**QUEANBEYAN-PALERANG REGIONAL COUNCIL
ORDINARY MEETING OF COUNCIL**

ITEM 9.1 DA.2023.0600 - ALTERATIONS AND ADDITIONS TO
DWELLING HOUSE - 28 RIVER DRIVE KARABAR

ASSESSMENT REPORT - DA.2023.0600

Proposal:	Alterations and additions to dwelling house
Address:	28 River Drive KARABAR NSW 2620
Property description:	Lot 16 DP 837155
Applicant:	Dolphin
Owner:	Emma Kate Martin & Brendan John McMahon
Date of lodgement:	02/12/2023
Notification period:	24/01/2024 to 09/02/2024
Submissions received:	Two
Assessment officer:	Ugyen Tenzin
Estimated cost of works:	\$500000.00
Zoning:	R3 - Medium Density Residential
Heritage:	Not applicable
Flood affected:	No
Bushfire prone:	Bushfire Prone (part)
Recommendation of officer:	Approval subject to conditions of consent

Figure 15: Comparative shadow diagrams (Source: PdD Building Design)

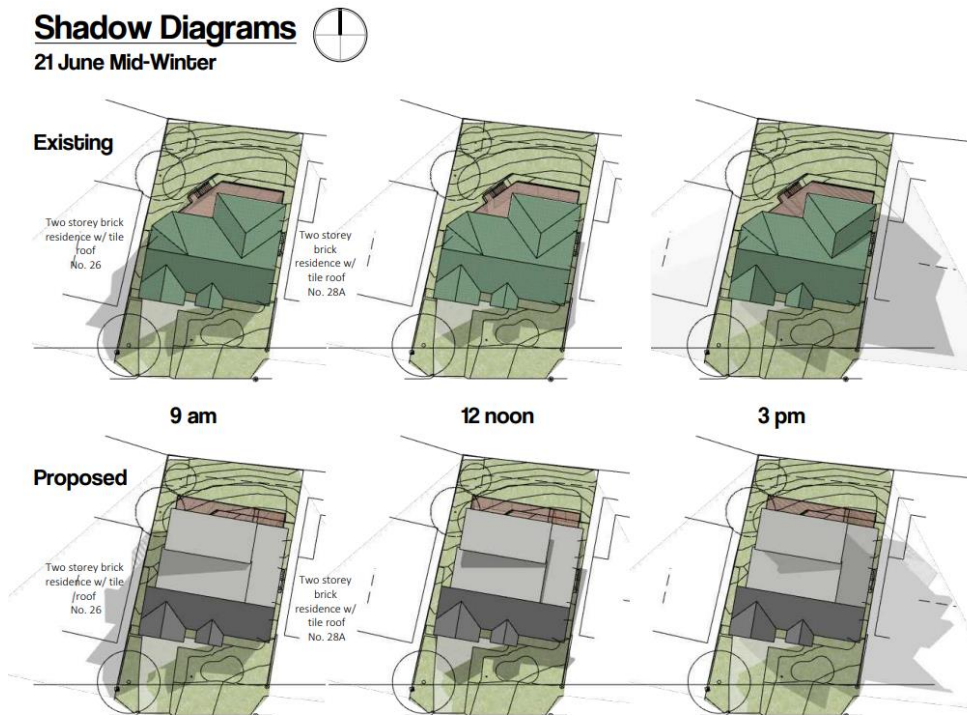
Comment: Though the proposed development extends beyond the existing building line to the rear, it has maintained a setback of 2.84m from its western boundary. Further, given the northerly orientation of the lots, there are no shadow impacts as seen in Figure 15 below.

Privacy issues are also adequately addressed as there is no window on the extended part of the western wall. The proposed bedroom window is offset from the existing window on the adjoining lot and is located at least 3m from the western boundary. The deck will also be screened. There are also trees along the lower part of the boundary providing natural barrier and privacy screen.
